**Table of Contents for 2818 Rio Grande Tree Permit**  
**Heritage Tree Variance Package**

**ITEM FOR PLANNING COMMISSION AGENDA**

**PROJECT NAME:** 2818 Rio Grande

**SUBJECT:** 2818 Rio Grande

# Exhibit 1

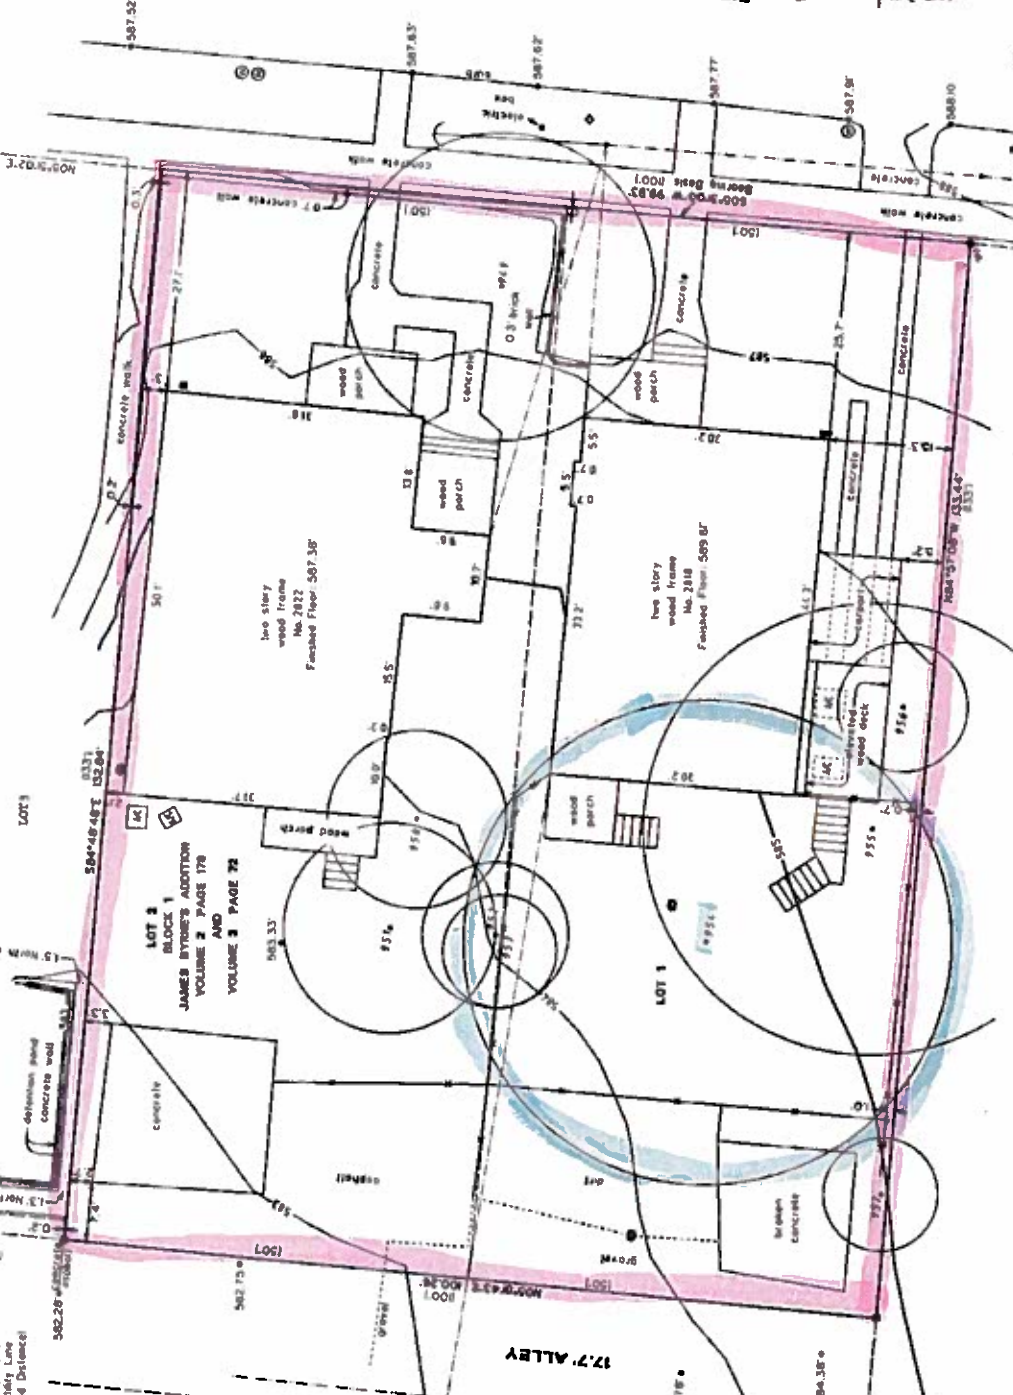
The subject property is comprised of two lots located at 2818 Rio Grande (Exhibit 1). The zoning is MF-4 and is adjacent to, but not in, the University Neighborhood Overlay District (UNO) (Exhibit 2). The zoning allows for 60 feet building height, .75:1 FAR, and 70% impervious cover. The desired use is an apartment building. The property is located in the Shoal Creek Watershed and is subject to urban watershed regulations.

= subject tree  
30" Pecan

Exhibit 3

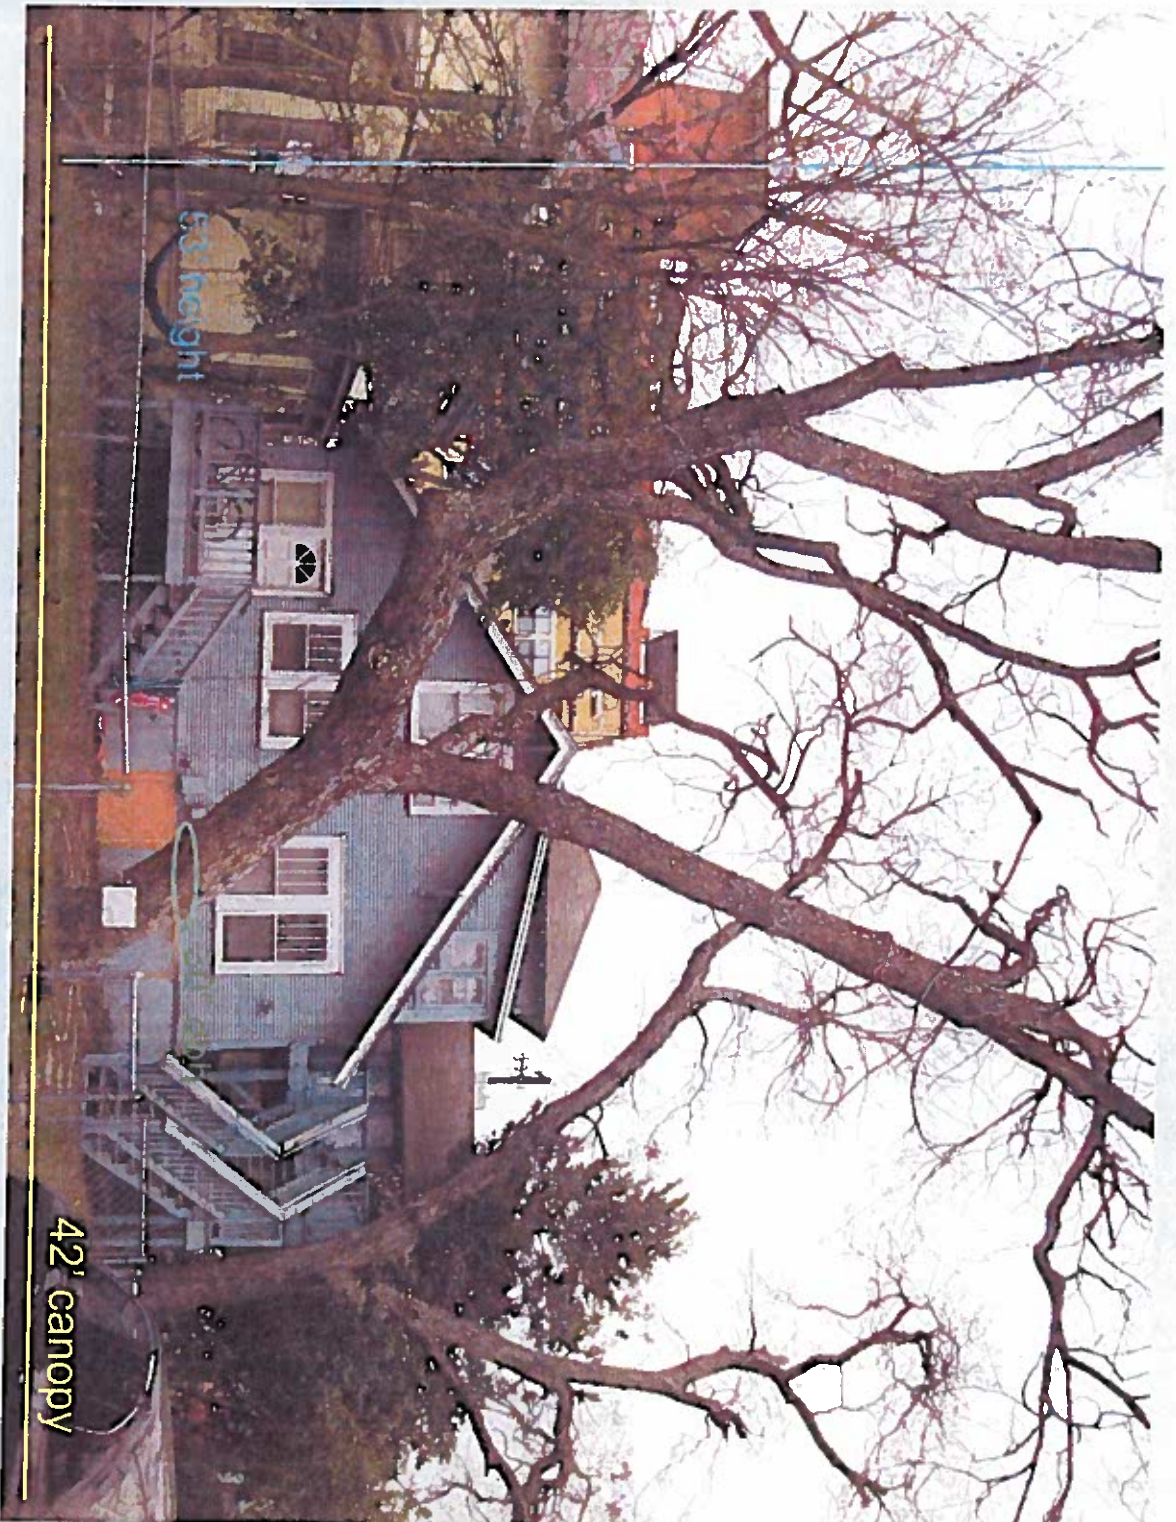
The subject tree is a 30.0 inch diameter at breast height (dbh) Pecan (*Carya illinoensis*). The tree height is 53 feet and the canopy spread is 42 feet (Exhibit 3). The tree has a 45 degree lean from vertical with no evidence of root decay or soil heaving (Exhibit 4).

Exhibit 5

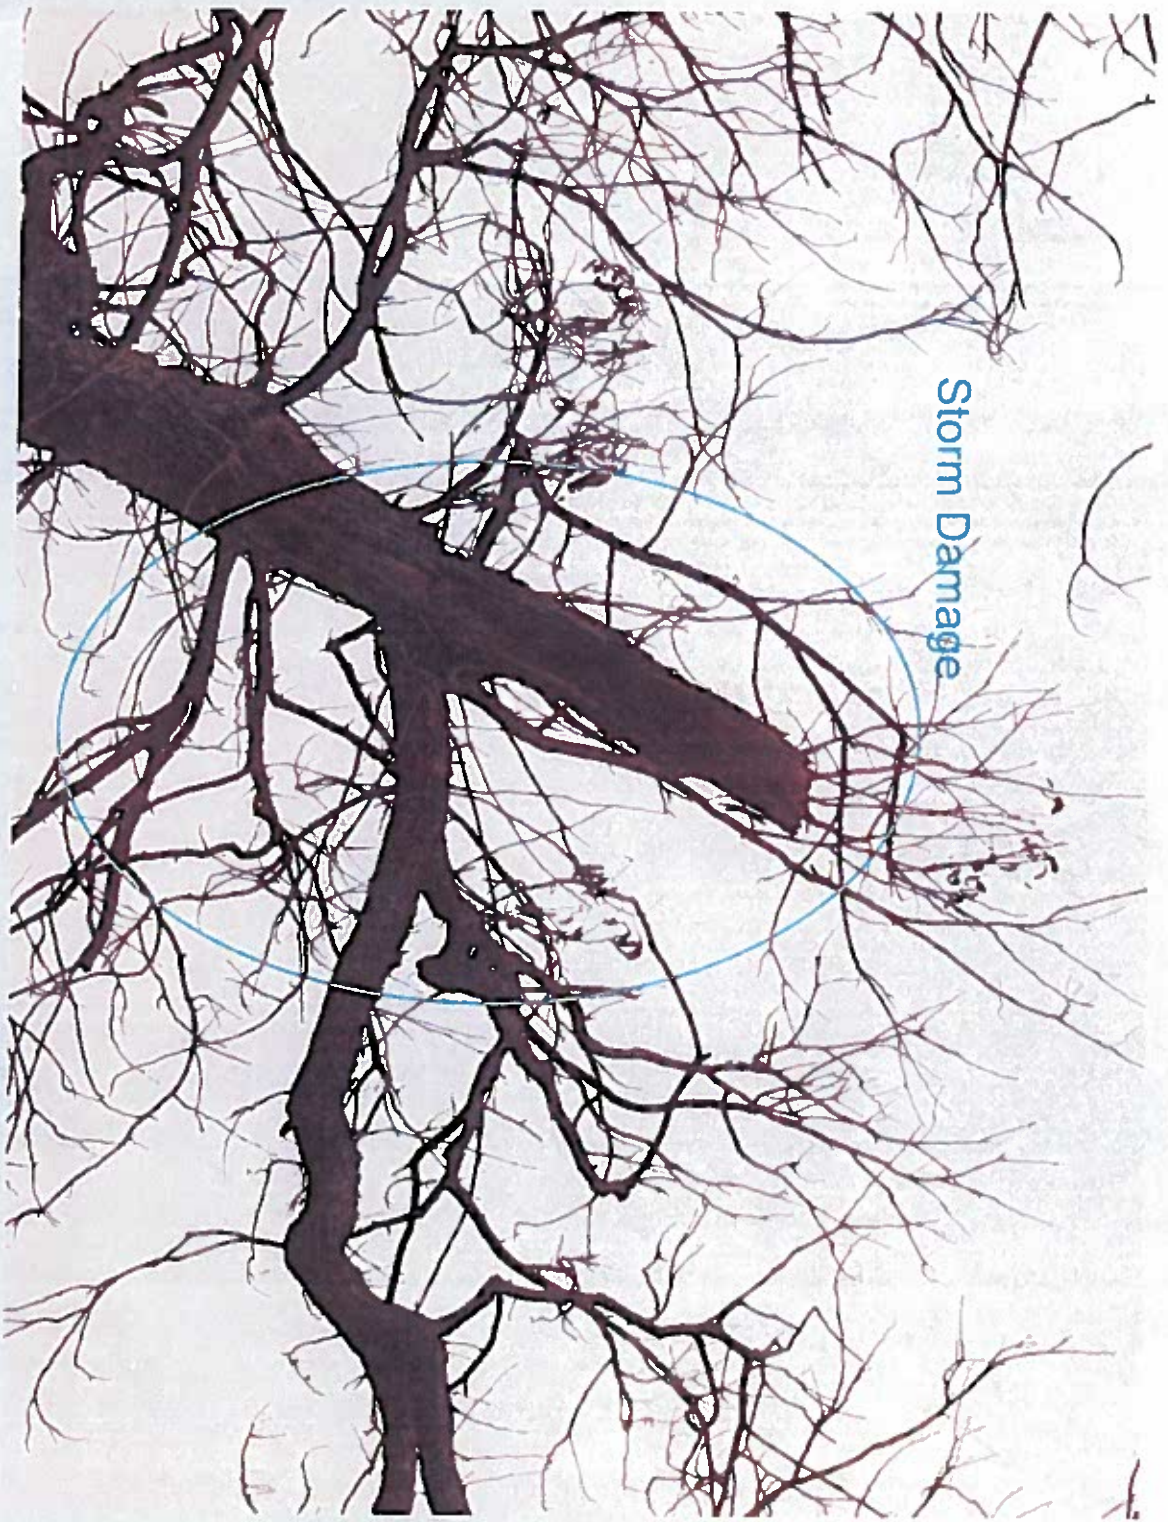
The canopy has major asymmetry, extensive storm damage, and moderate decay. Storm damage is evident by the presence of multiple broken stems and subsequent decay (Exhibits 5, 6, 7 and 8).

Exhibit 9

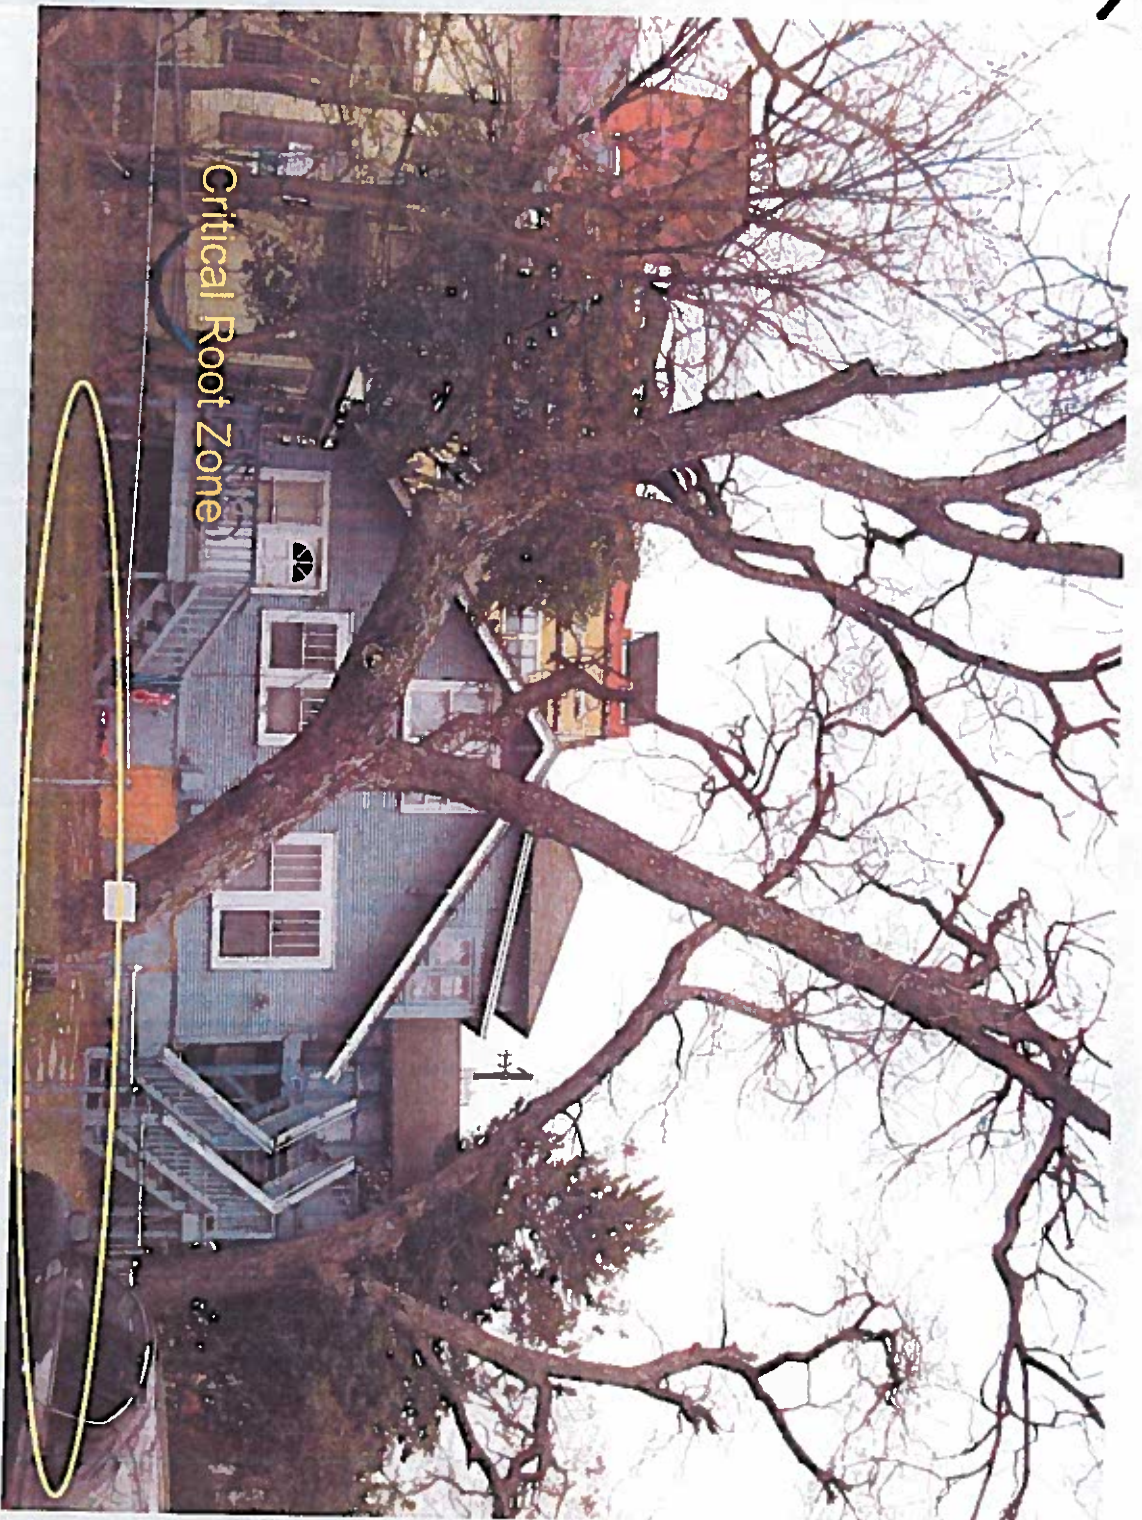
Critical root zone conditions are characterized by compacted turf grass and bare soil, base material serving as a parking lot, and a housing structure (Exhibit 9). Root flare is present with no signs of wounding or decay.

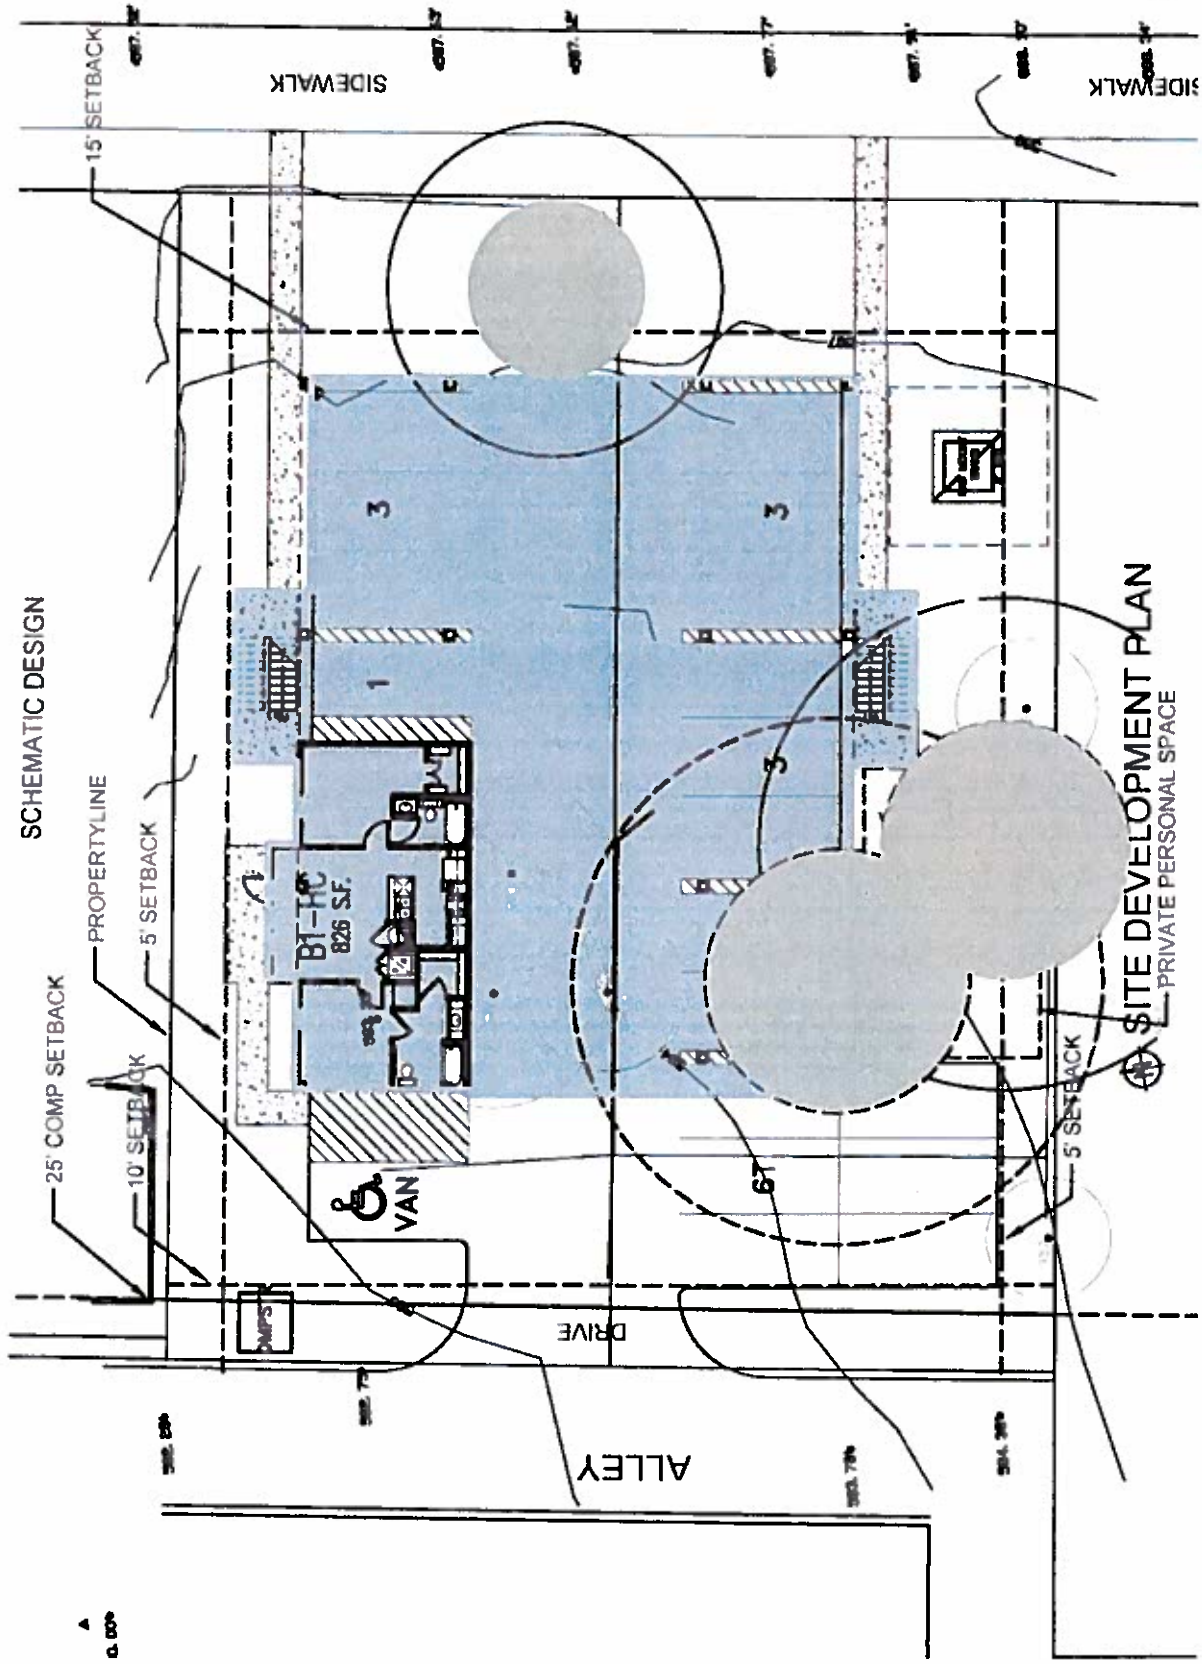
Mike, I can't move the building any closer to rio grande because of the other tree there, unless Embezi is willing to let that one go? I highly doubt it.

I'll have to fracture the rectangular shape of the building to dodge the trees.

See attached pdf. As you can see, the layout was perfect when the leaning pecan wasn't a player.
